## DART SERVICE INSTRUCTION

TO AMEND INSTALLATION INSTRUCTIONS 301-102000-001 REV. C OR LATER APPROVED REVISION REF. TCCA STC: SH19-26

REF. FAA STC: SH8801SW-D

## **PURPOSE** 1.0

Figure 2: Mirror Attachment Post Remove

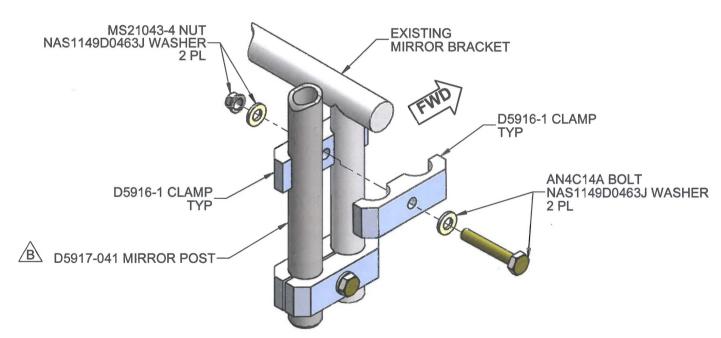
- Remove both the rectangular (Airbus) and round (Simplex) mirrors from the Airbus mirror bracket. 2.1.1
- 2.1.2 Trim the existing Airbus mirror bracket (Figure 1) to remove the outer mirror attachment post (Figure 2).
- 2.1.3 Install the round (Simplex) mirror as shown in Figure 3. Torque fasteners to 50-70 in-lbs [2.3-2.8 N-m].
